Project BLACKTOWN WORKERS SENIORS LIVING - INDUSTRIAL PARK ROAD ANDRELL PARK NSW	Scale As indicated @A1	Drawing Title MASTERPLAN - SECTIONS - SHEET 1	Issue B
Client Paynter Dixon www.paynter-dixon.com.au	Author AJ+C ALVIN JENNY COTTELL 79 Maple Street, Chippendale NSW 2008 AUSTRALIA ph +61 2 8511 8222 fax +61 2 8511 8200 ABN 53 003 762 250	Sheet Status NOT FOR CONSTRUCTION	Project No. 17002

Project	BLACKTOWN WORKERS SENIORS 170 RESERVOIR ROAD ANNIELL PARK, NSW	Scale	1:200 @A1	Drawing No.	DA2100 D																									
Architect	AJ+C 78 Maple Street, Chesham NSW 2869 AUSTRALIA PH +61 2 8311 8221 x +61 2 8311 5200 ABN 53 003 762 250	Drawing Title	STAGE 1 - LEVEL 1 (GROUND) PLAN																											
Client	PAYNTER DIXON CREATING SINCE 1914 www.paynterdixon.com.au	Drawing Scale	NOT FOR CONSTRUCTION																											
Key																														
Revisions

BLACKTOWN WORKERS CLUB SENIORS LIVING

MASTERPLAN REPORT - LANDSCAPE

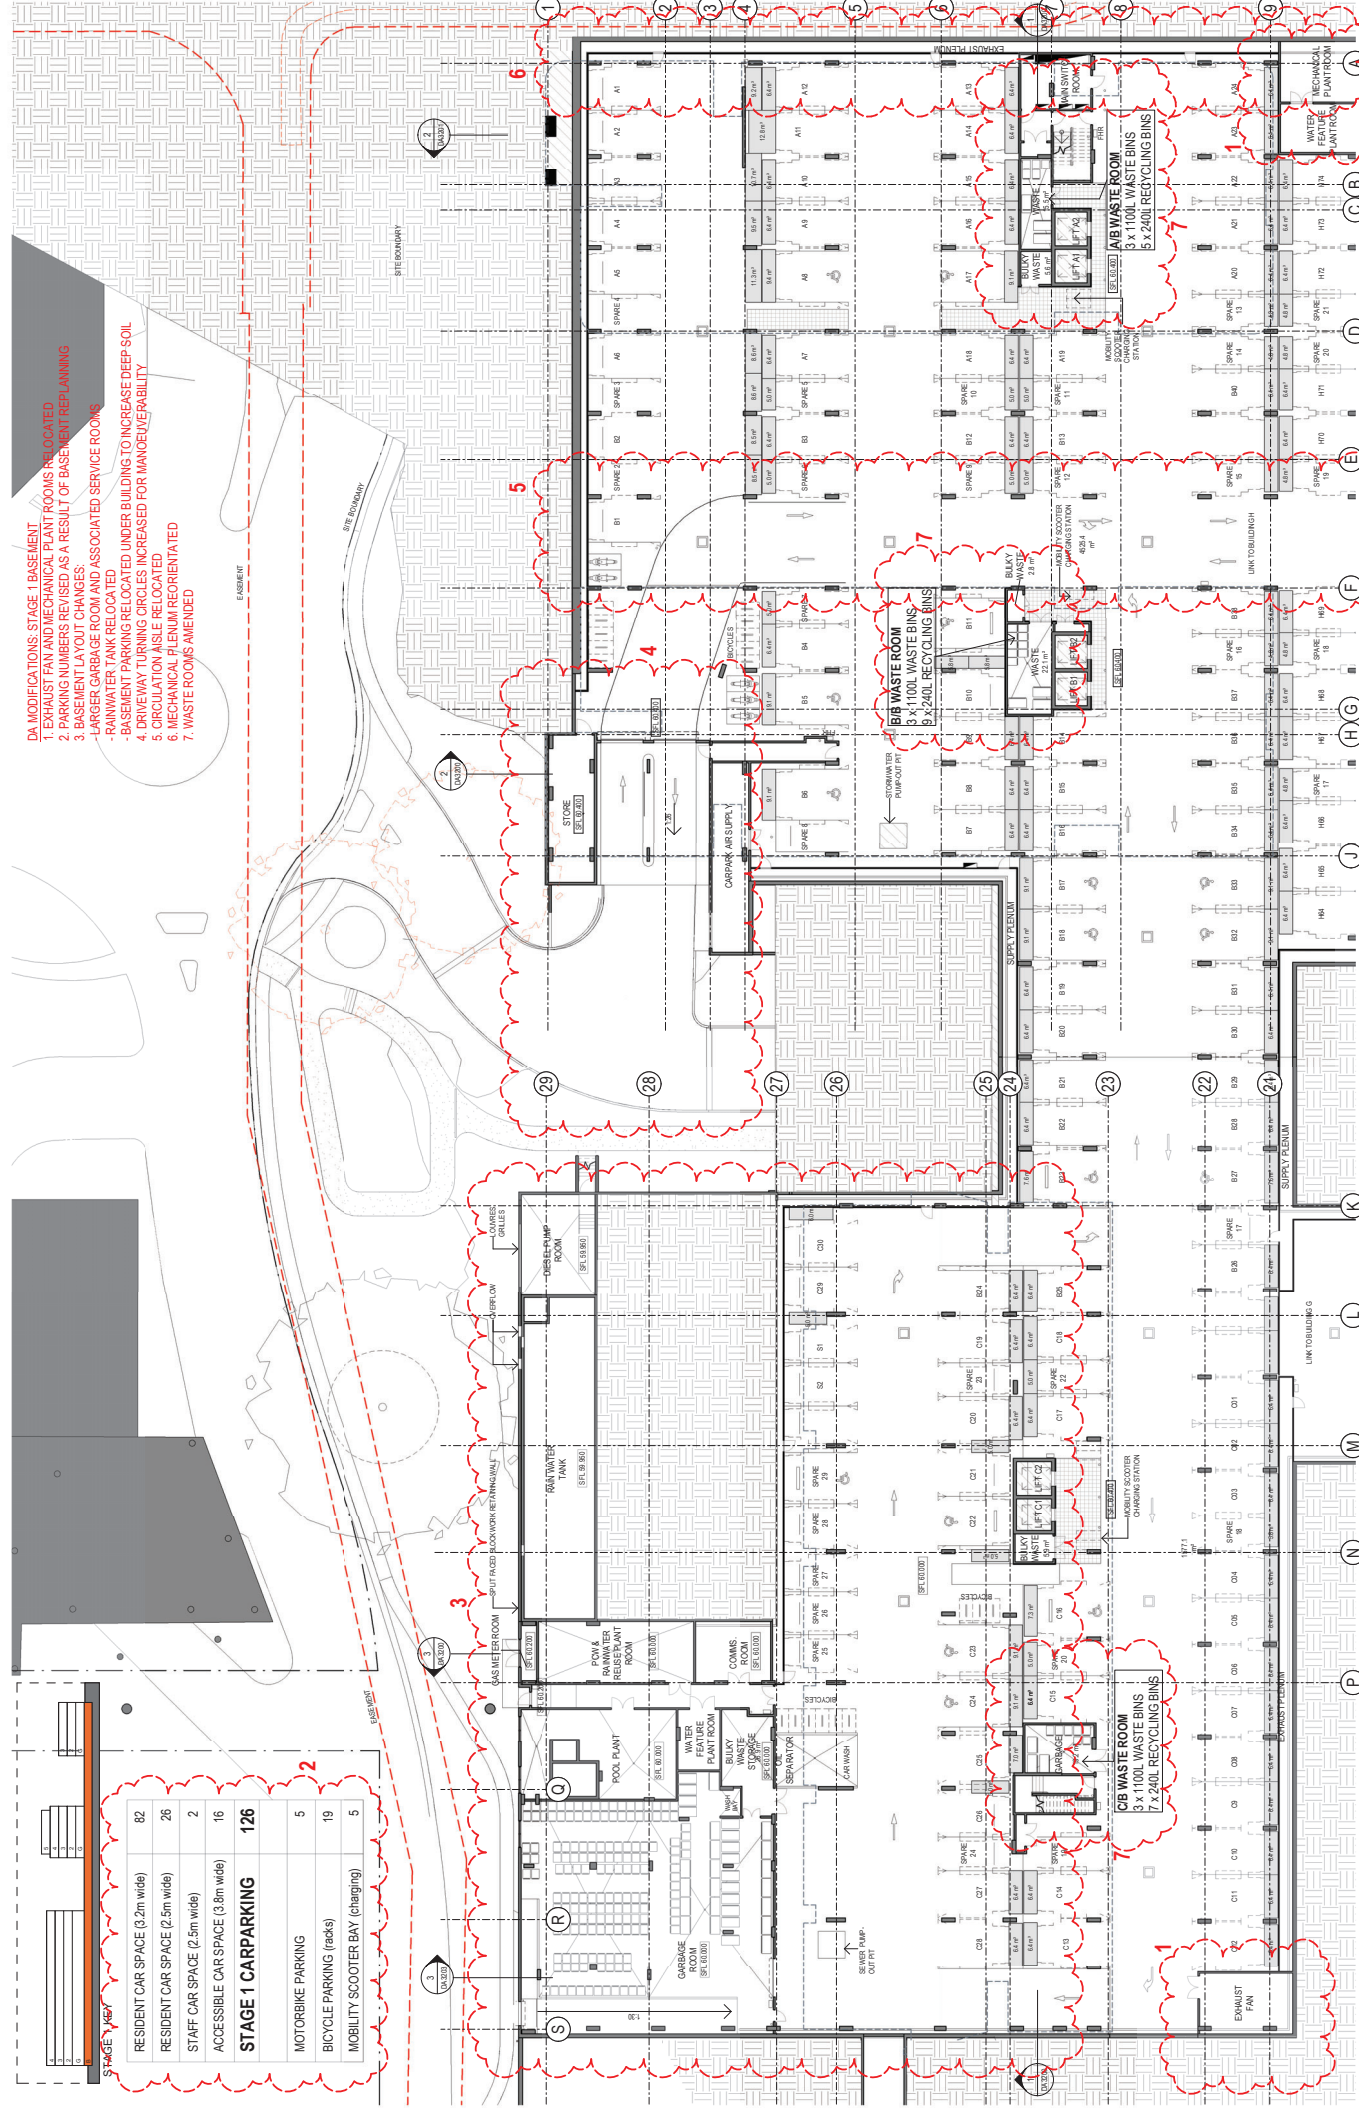
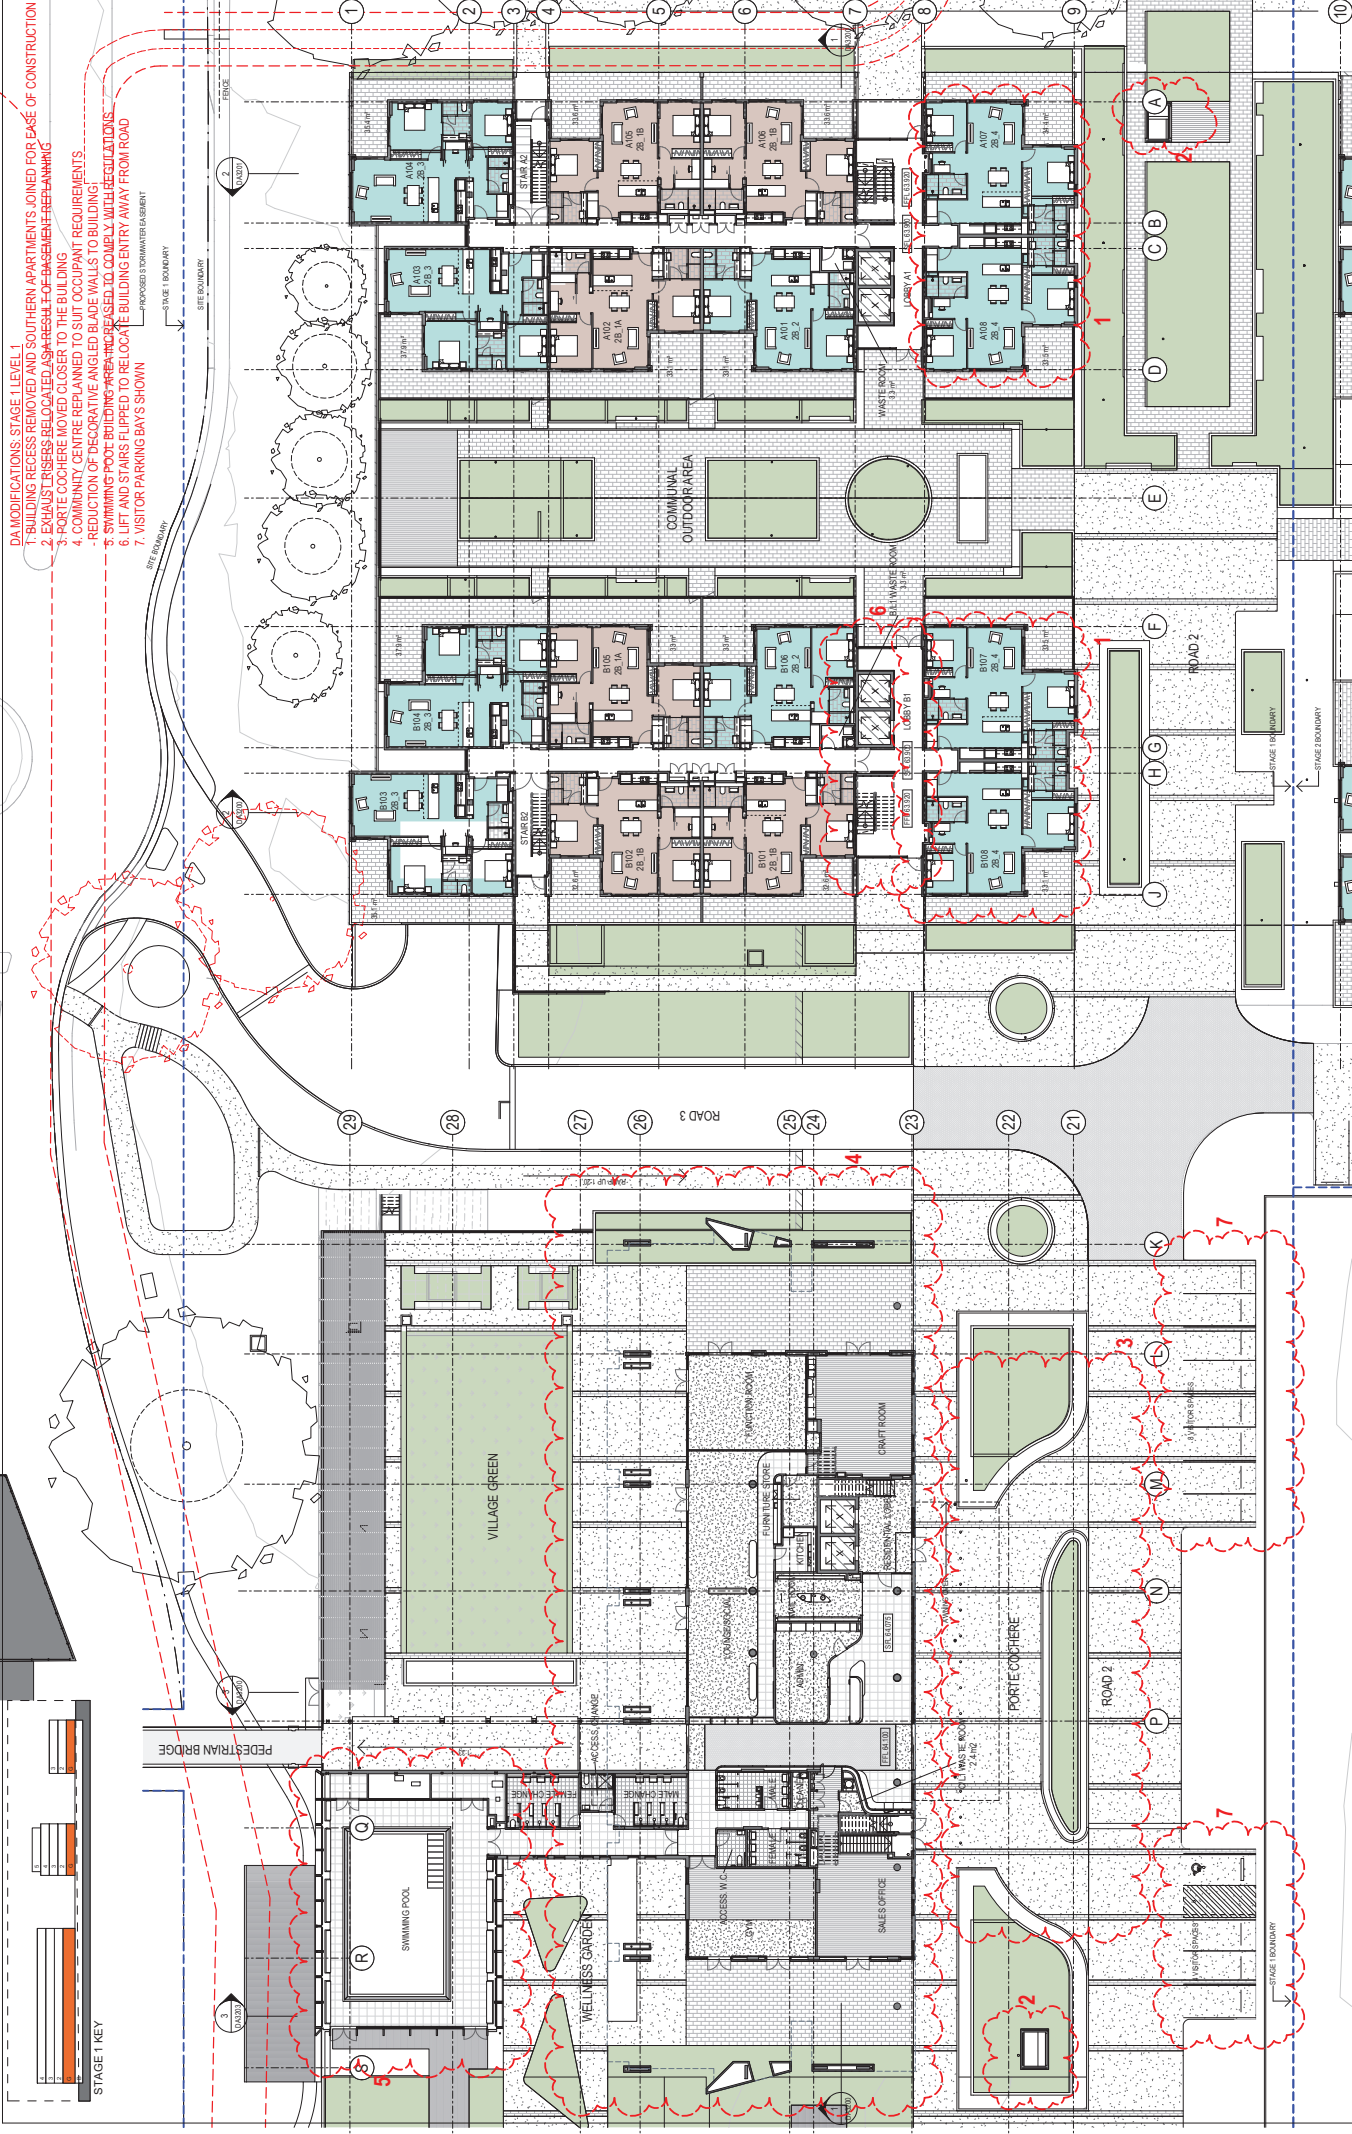
- DA MODIFICATIONS, STAGE 1 LEVEL 1
1. BUILDING RECESS REMOVED AND SOUTHERN APARTMENTS JOINED FOR EASE OF CONSTRUCTION
 2. EXHAUST RISERS RELOCATED AS REQUIRED FOR BASEMENT RE-PLANNING
 3. PORTE COCHERE MOVED CLOSER TO THE BUILDING
 4. COMMUNITY CENTRE REPLANNED TO SUIT OCCUPANT REQUIREMENTS
 5. REDUCTION OF DECORATIVE ANGLED GLASS WALLS TO BUILDING
 6. SWIMMING POOL BRIDGING AREA REDESIGNED TO COMPLY WITH REGULATIONS
 7. LIFT AND STAIRS FLIPPED TO RELOCATE BUILDING ENTRY AWAY FROM ROAD
 8. VISITOR PARKING BAYS SHOWN

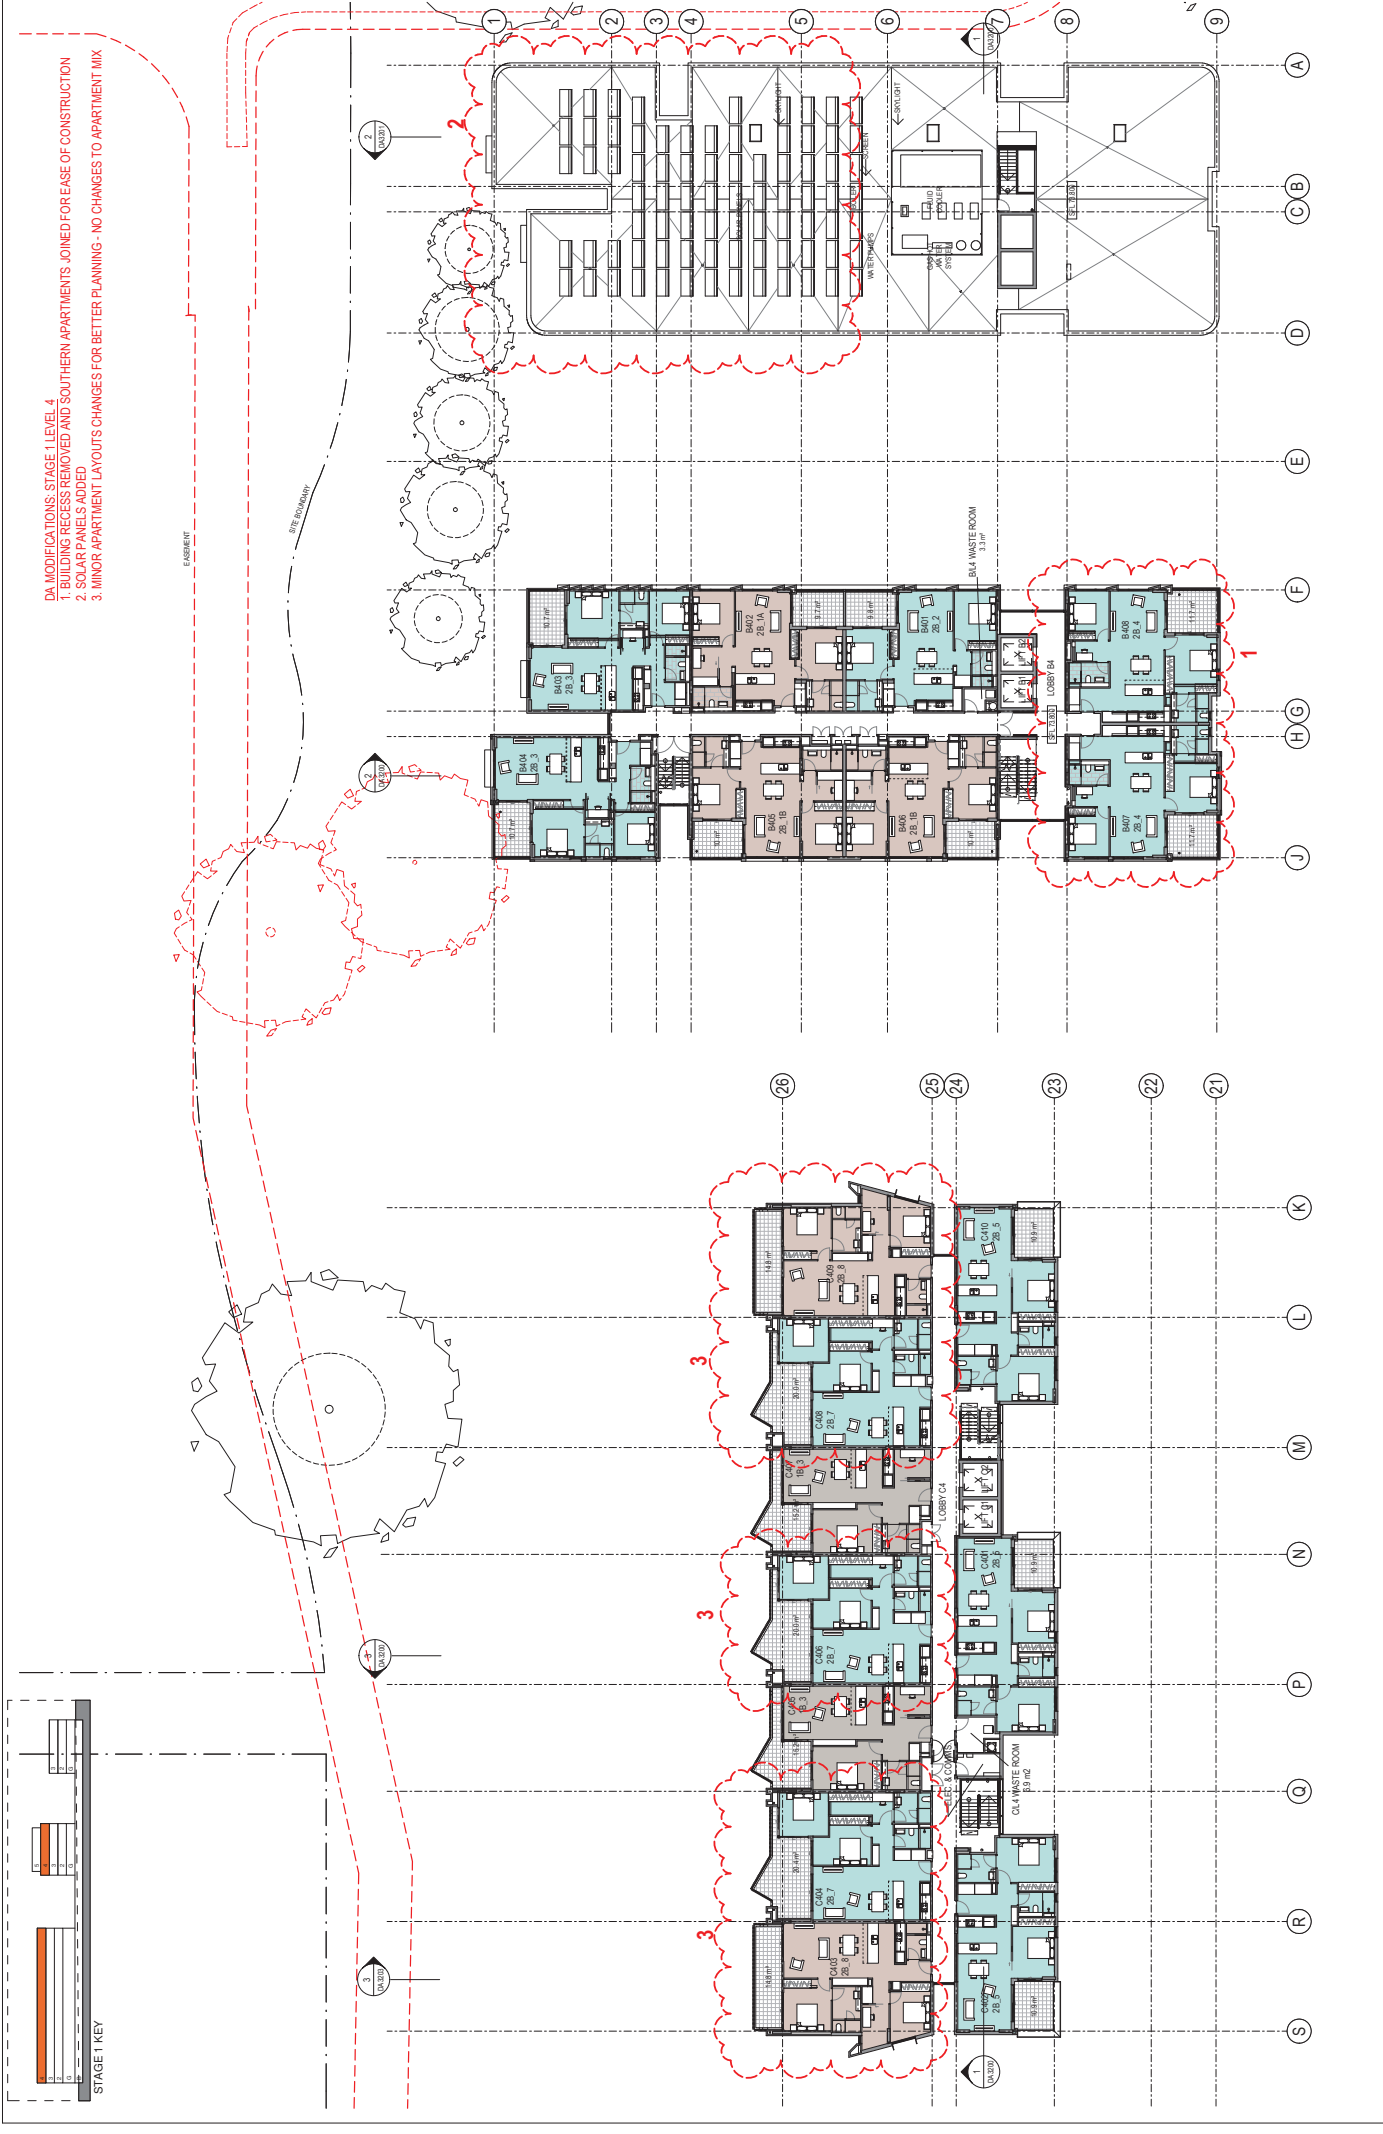
- DA MODIFICATIONS: STAGE 1 LEVEL 4
1. BUILDING RECESS REMOVED AND SOUTHERN APARTMENTS JOINED FOR EASE OF CONSTRUCTION
 2. SOLAR PANELS ADDED
 3. MINOR APARTMENT LAYOUTS CHANGES FOR BETTER PLANNING - NO CHANGES TO APARTMENT MIX

Drawing Title	STAGE 2 - LEVEL 4 PLAN
Drawing Status

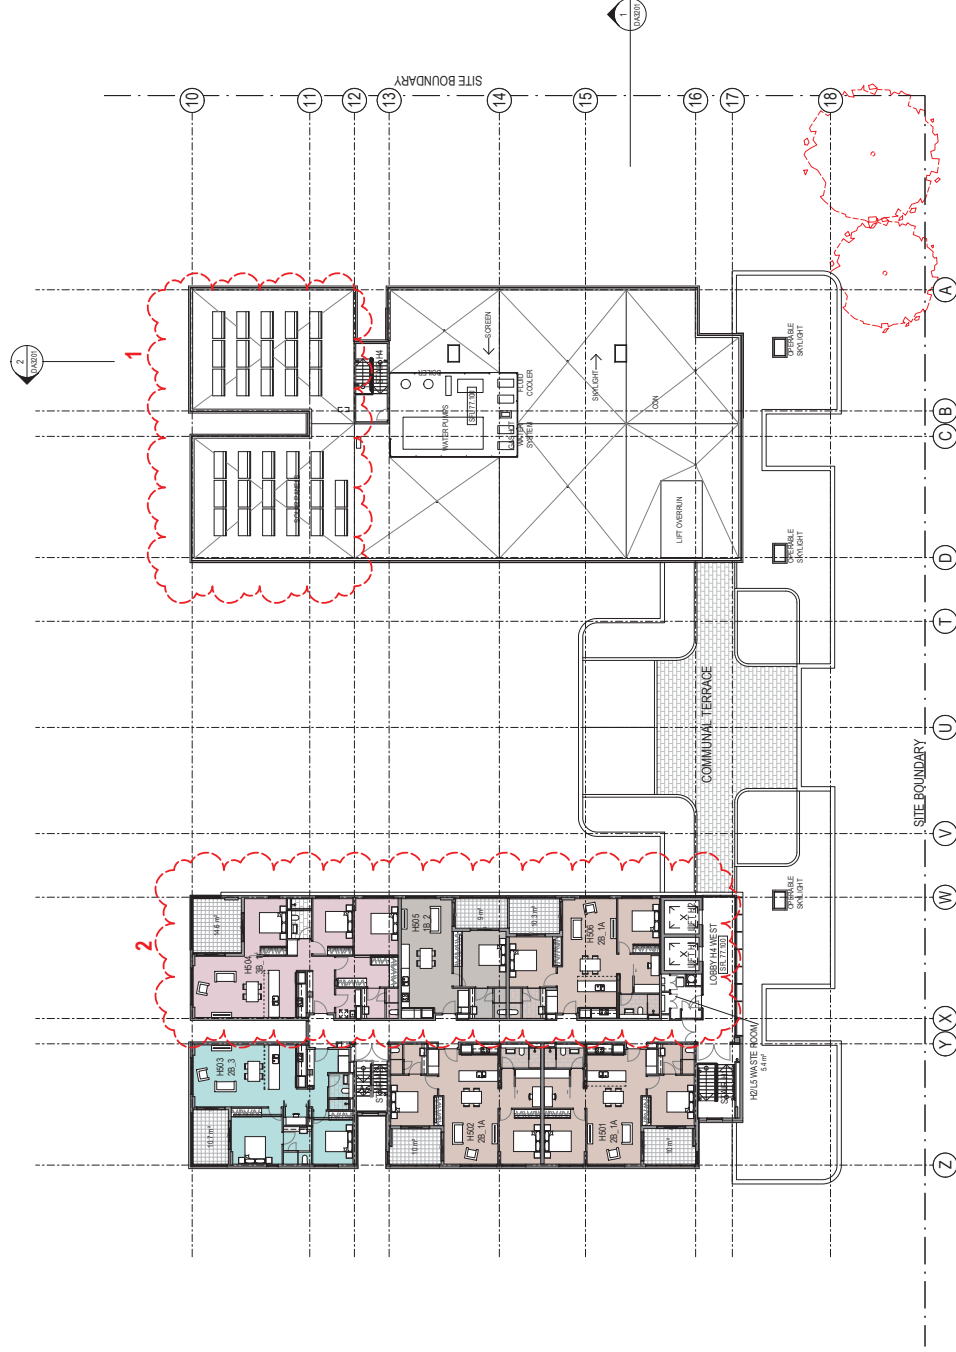
1. SOLAR PANELS ADDED
2. APARTMENTS RELOCATED - NO CHANGE TO APARTMENT MIX OR FLOOR AREA
